RE: RESPONSE TO INFORMATION REQUEST A MATERIAL CHANGE OF USE (DWELLING HOUSE) OVER LAND AT 14 HIBISCUS COURT, ROCKY POINT, MORE FORMALLY DESCRIBED AS LOT 26 ON RP749732

COUNCIL REF: MCUC 2022_4956/I (Doc ID 1105534)

Attachment I:

Amended Proposal Plans

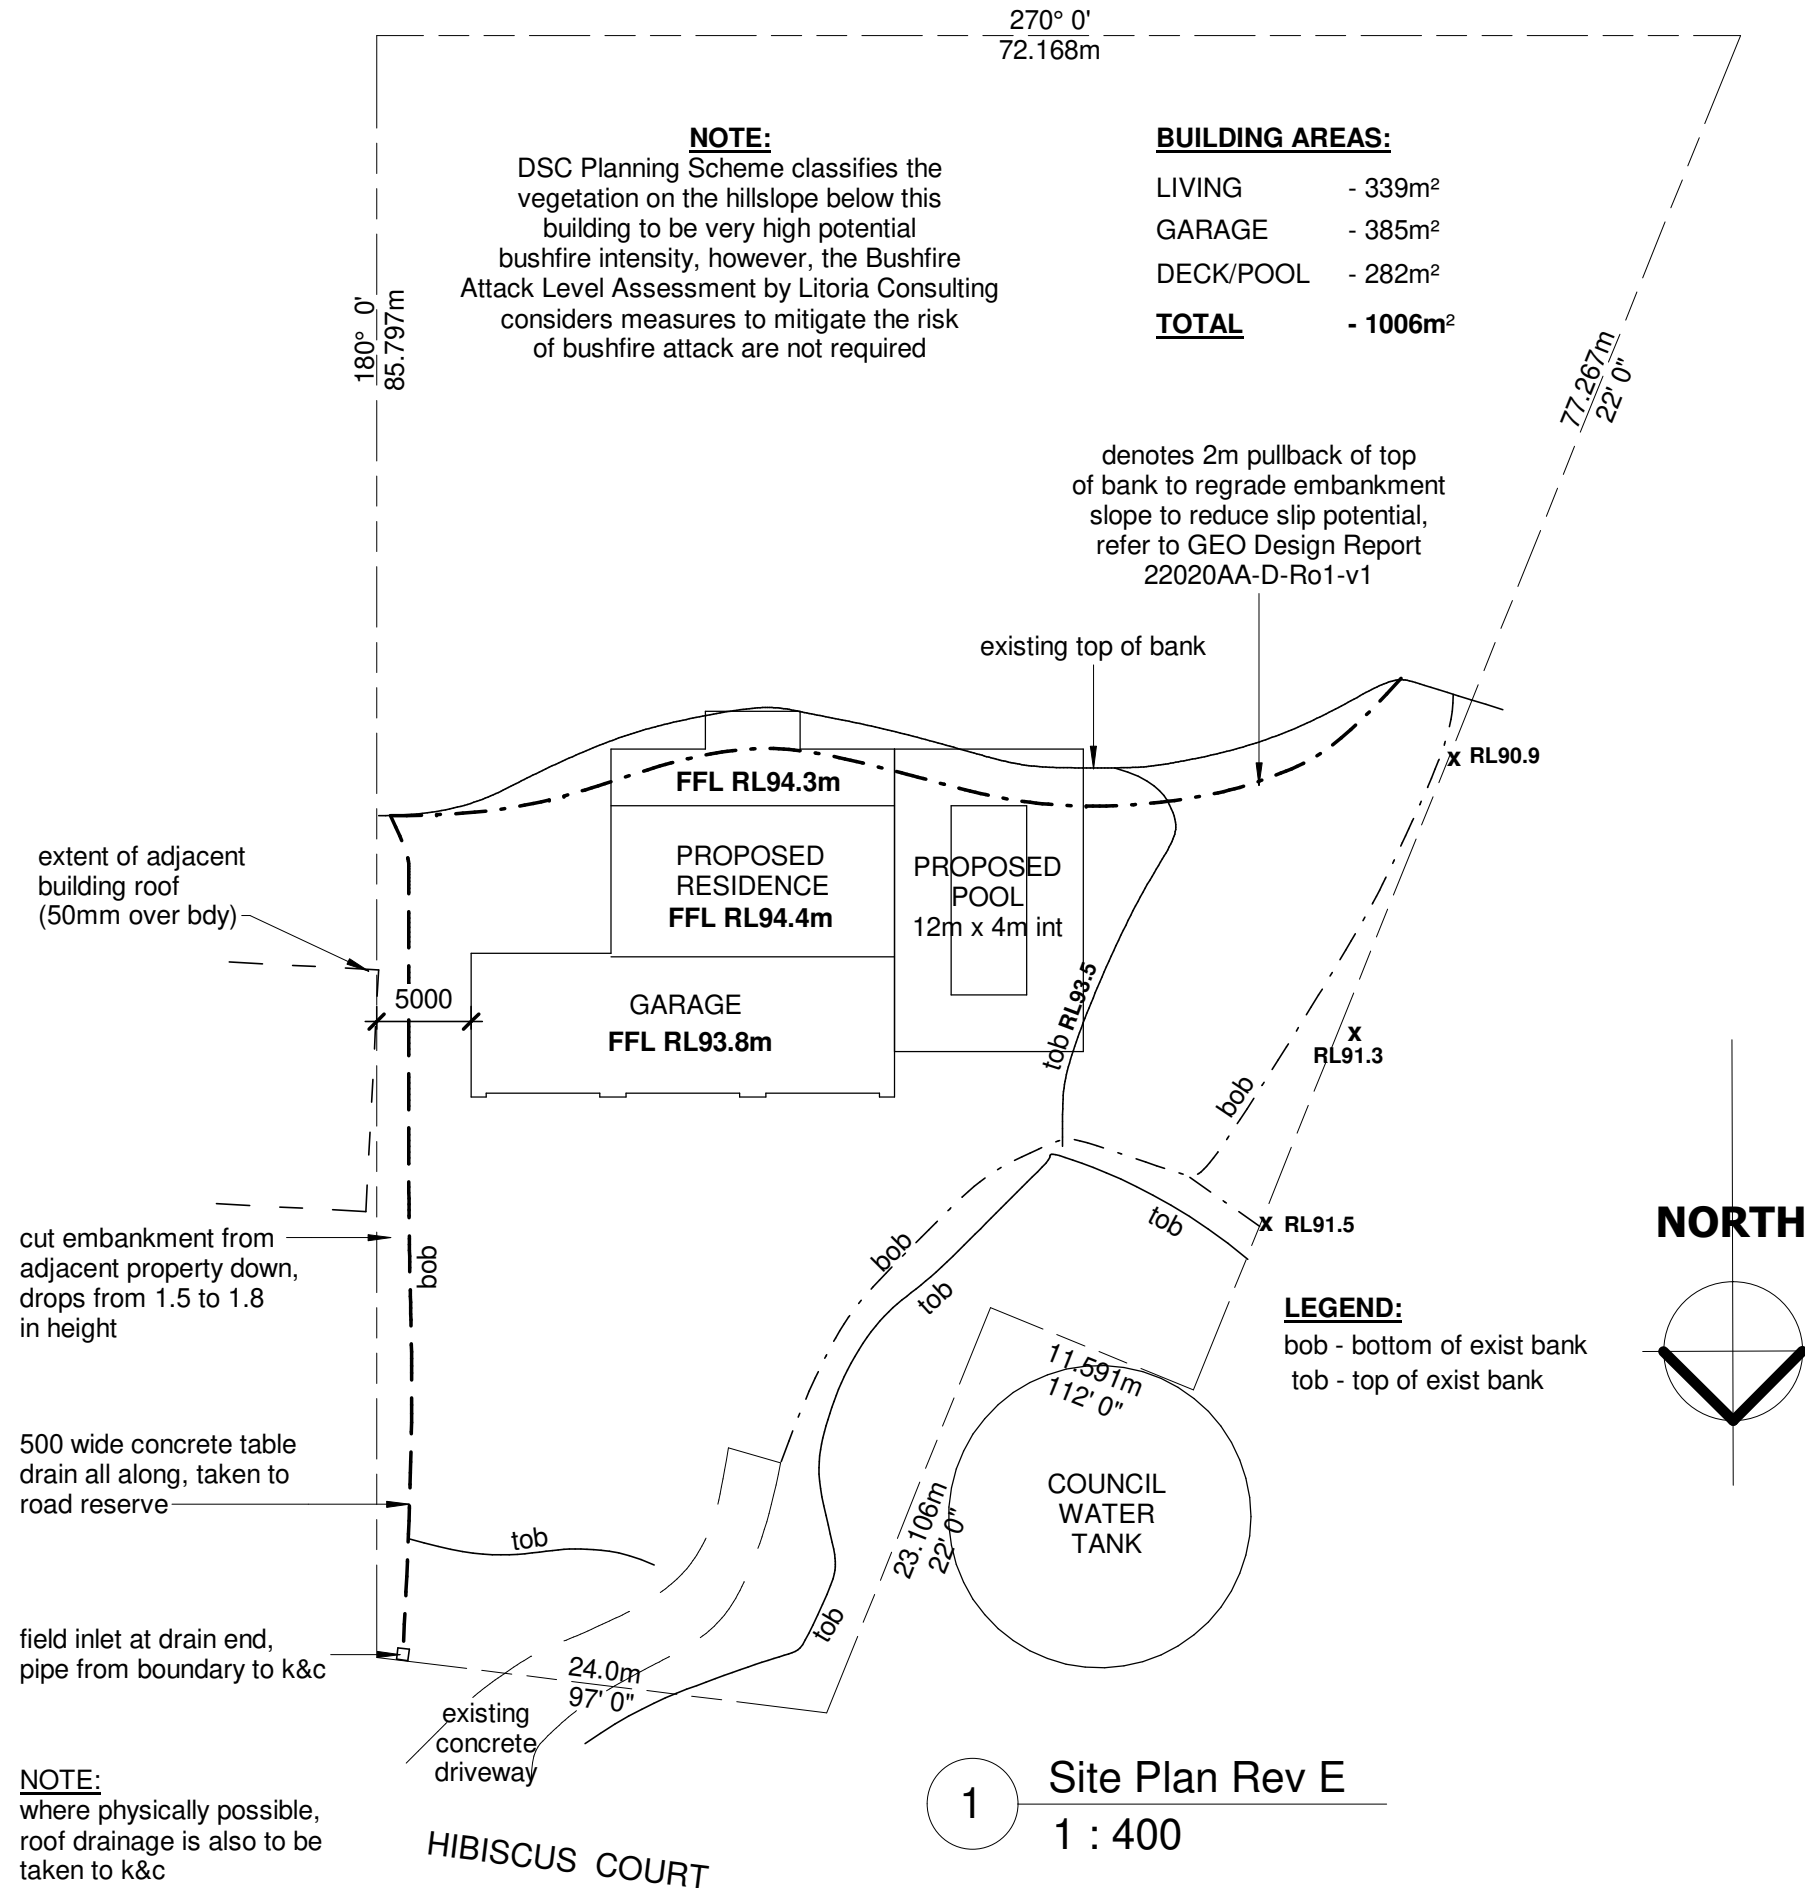
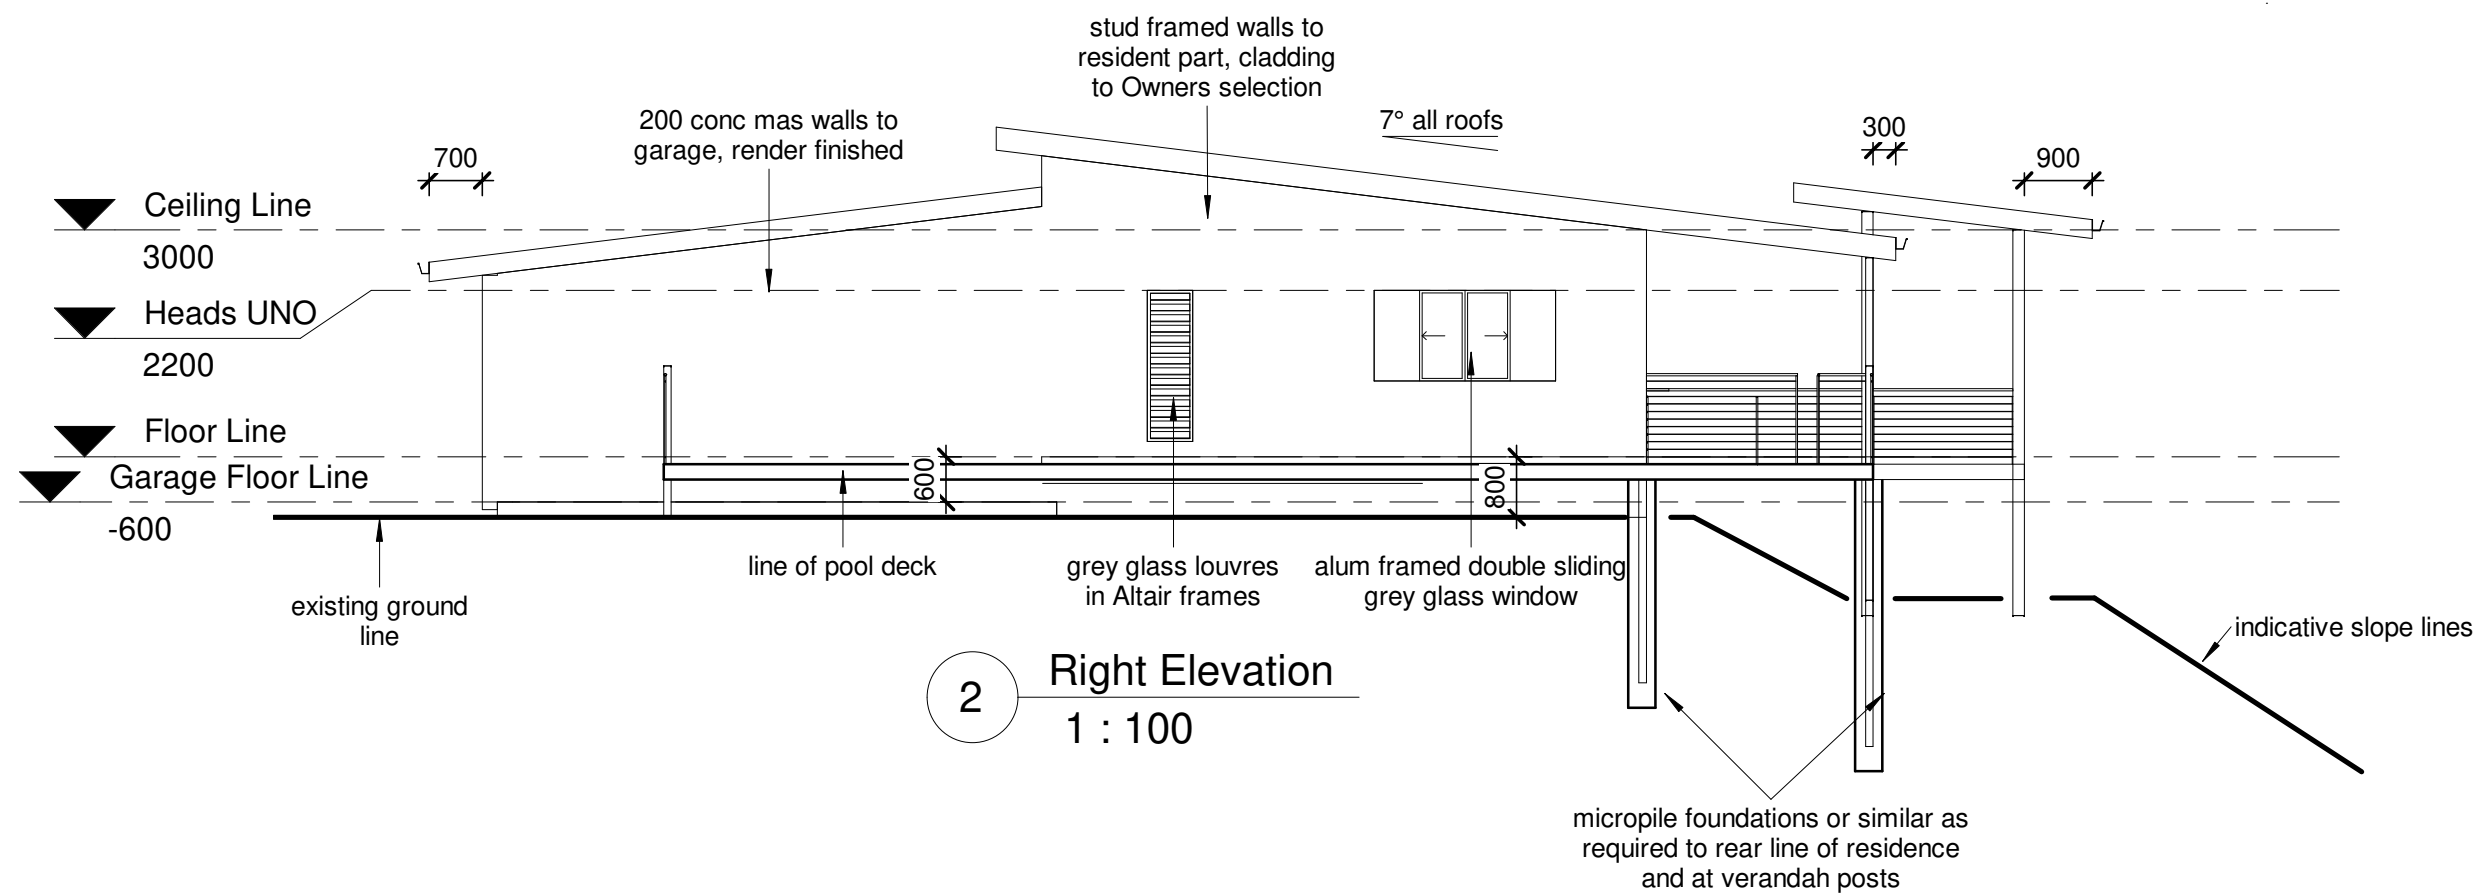
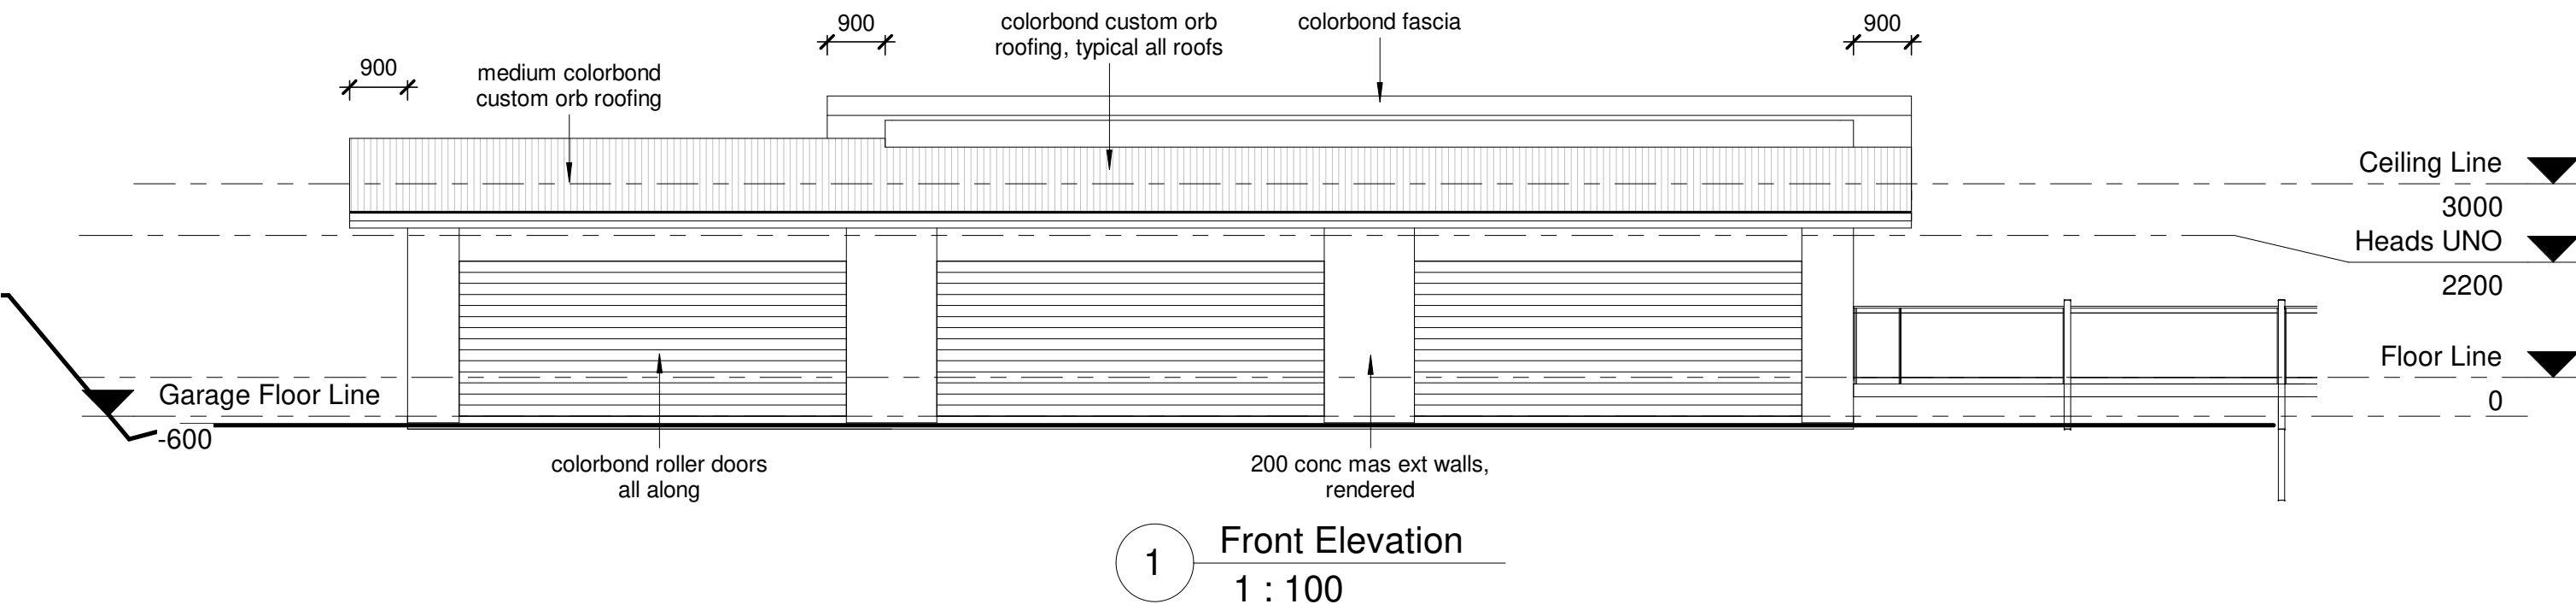
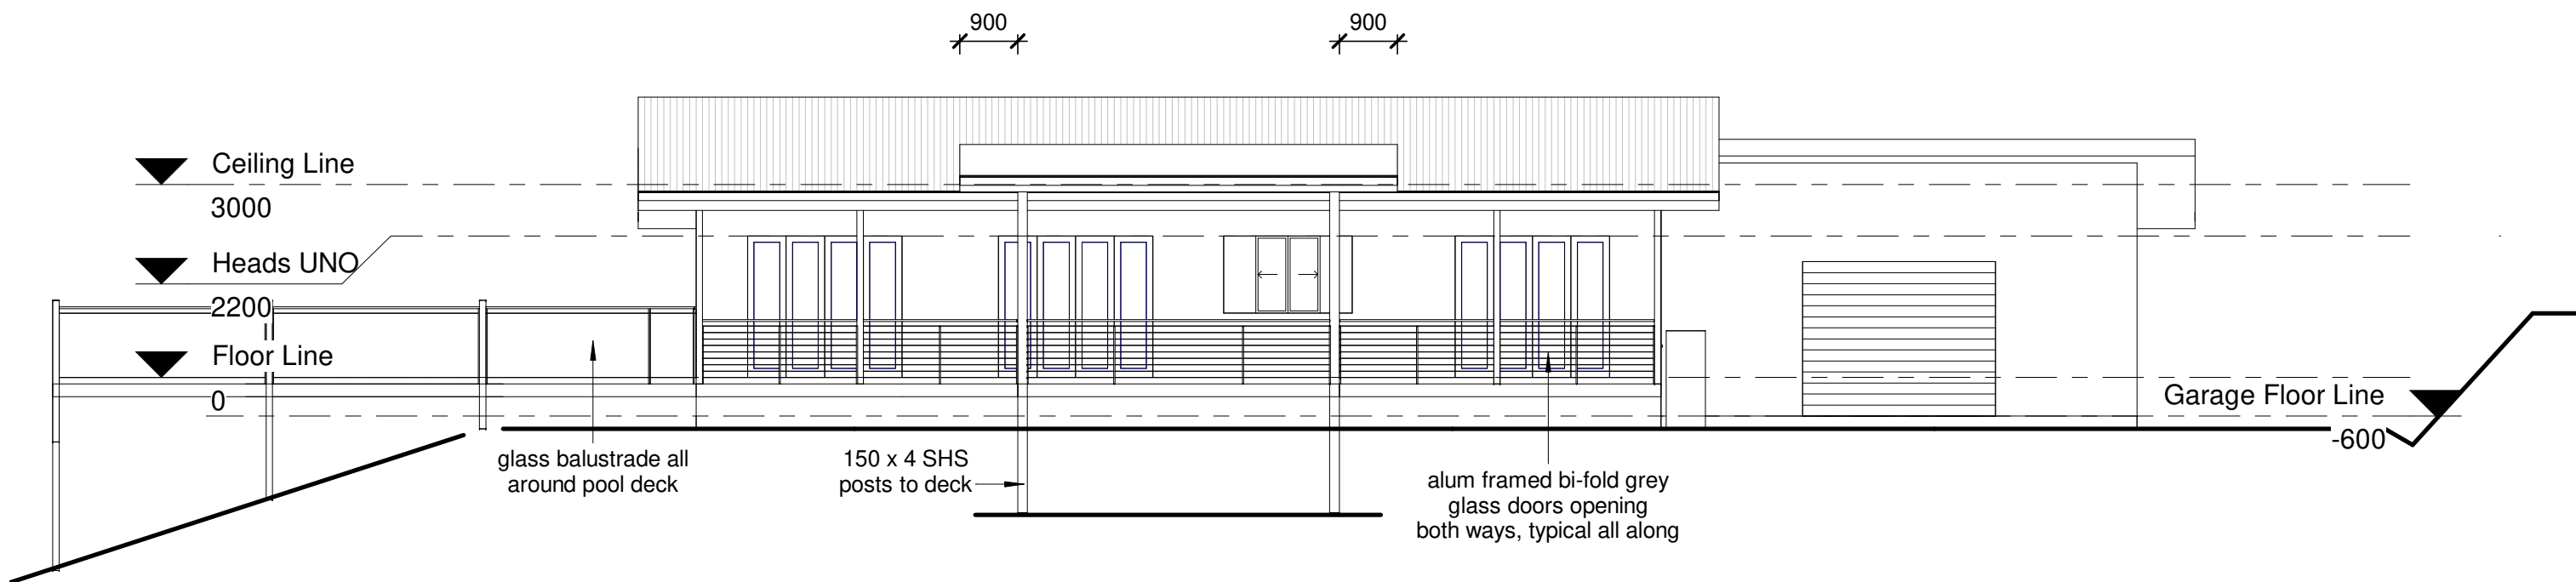
Since the issue of the Information Request on the 30 August 2022, the currency of the Development Application has been maintained through mutual agreement to extend the Information Response Period. As a result of the Information Request and other factors the proposed Dwelling House has been through a number of design iterations. The main notable change is a reduction in the size of the proposed cantilever deck. This now generally aligns with the existing top of bank. The revised plans are included under Attachment I.

It is understood that the requirement for a Visual Assessment was likely driven by the proposed cantilevered building elements and with the amended design the building is now largely limited to the existing top of bank. It is proposed to pull back the existing top of bank by 2m in accordance with the GEO Design Report which will result in slight protrusion over the new top of bank.

It is acknowledged that the site and proposed development is assigned a medium risk under the GEO Design Geotechnical Investigation. However, under s4.7.1 states that following re-profiling, and the adoption of the drainage and erosion protection measures, that it is considered the batter would have a Low Risk in accordance with the AGS 2007 guidelines. The proposed extent of re-profiling is illustrated on the Revised Proposal Plans included under Attachment 1, i.e. 2m pullback of top of bank.

The proposed retaining wall along the western boundary has been removed from the current design. No changes are proposed to the ground levels in this area.
